Subject: Finding of No Significant Impact (FONSI) for  
Halona Blowhole Lookout Renovation  
TMK: 3-9-012: por. 2; Maunalua, O'ahu, Hawaii

## FINAL ENVIRONMENTAL ASSESSMENT

*HALONA BLOWHOLE LOOKOUT RENOVATION*  
Maunaloa, Oahu, Hawaii

**HALONA BLOWHOLE CONCEPTUAL PLAN**

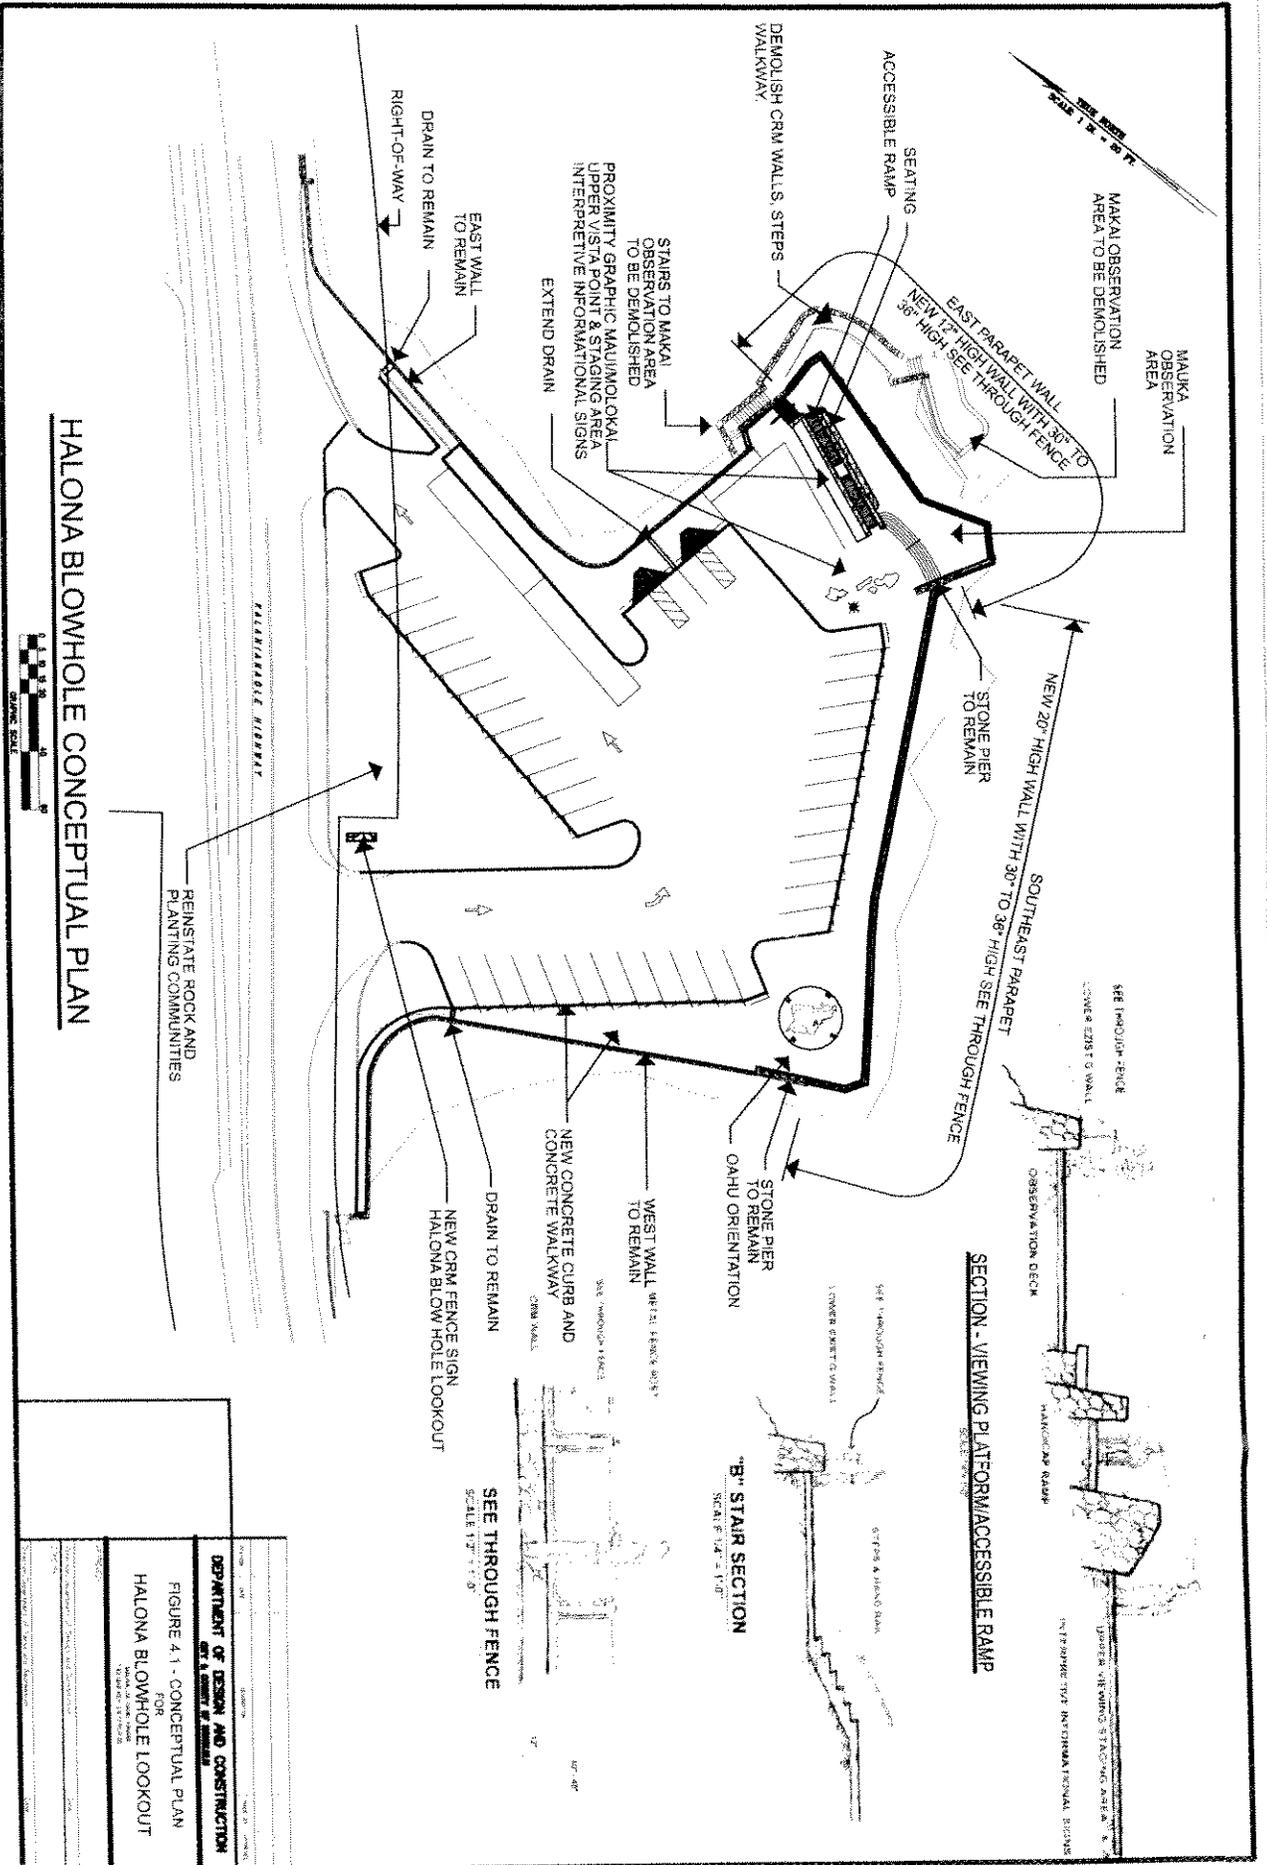
4. There is a "drain to remain" notation on the right side of the Halona Blowhole Conceptual Plan. However, there is no arrow showing the location of the drain. Please show the drain location.

The east CRM wall facing Sandy Beach and the west CRM wall facing Halona Cove are in good condition and will remain intact. **A revised Conceptual Plan is shown on Figure 4.**
